N59 Oughterard Bridge Traffic Management & Signals Design

Quality Audit

Stephen Reid Consulting Traffic and Transportation

February 2023

Figure 3.1 – Forward Visibility to Primary Traffic Signal for Left Turners

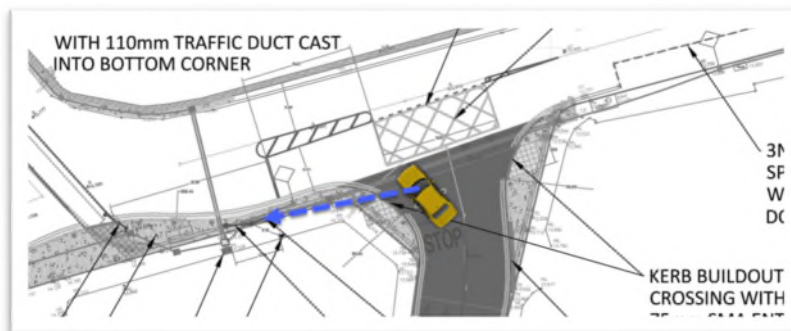
3.1 Problem: Registering the Presence of Traffic Signals

Location: Vehicles Turning Left from Station Road to N59 Westbound

The angle of approach for left-turning vehicles from Station Road could result in drivers being offered limited forward visibility to the traffic signals. This could lead to conflicts with vulnerable road users or opposing vehicles on the N59.

Recommendation

Drivers should be afforded with appropriate forward visibility to the traffic signal heads at this location. This could be coupled with suitable road markings and signage to inform side road drivers that they will be approaching a traffic signal controlled junction.

2.1	Yes	Yes	<p>Forward visibility of the primary and secondary traffic signals has been checked in accordance with TSM Ch.9 and heads aligned so the aspects meet the requirements therein. With regards to the visibility of the traffic signals for traffic exiting from Station Road it is noted that both primary and secondary signal heads are aligned facing the N59 westbound approach, but the angles are shallow enough to afford good visibility for traffic approaching the turnout point onto the N59 from Station Road. To demonstrate this, note below the dashed lines showing TSM visibility alignment (yellow highlighted is primary and green highlighted is secondary). The green highlight line is extended through beyond the 2.5m stopline setback measurement point to the centre of the Station Road, and in addition the blue highlight line shows visibility to the primary from the centreline of the Station road at the proposed setback stopline.</p>  <p>Designer note: the TS installers should check alignment on site and ensure that no additional road signs or cowls on red or amber signal aspects are located</p>	Noted & agreed

Problem Reference (Section 2)	Designer Response Section			Audit Team Response Section
	Problem Accepted (yes / no)	Recommended Measure Accepted (yes / no)	Alternative Measures or Comments	Alternative Measures Accepted (yes / no)
			<p>where these could block visibility for traffic exiting from Station Road.</p> <p>A W042 Traffic Signals Ahead sign is to be installed on each of the signalised arm approaches.</p> <p>If viewed as appropriate a sign with a supplementary left pointing arrow plate P003L could be installed on Station Road approaching the N59 junction (see below).</p> <div style="text-align: center;">  <p>P 003L</p> </div>
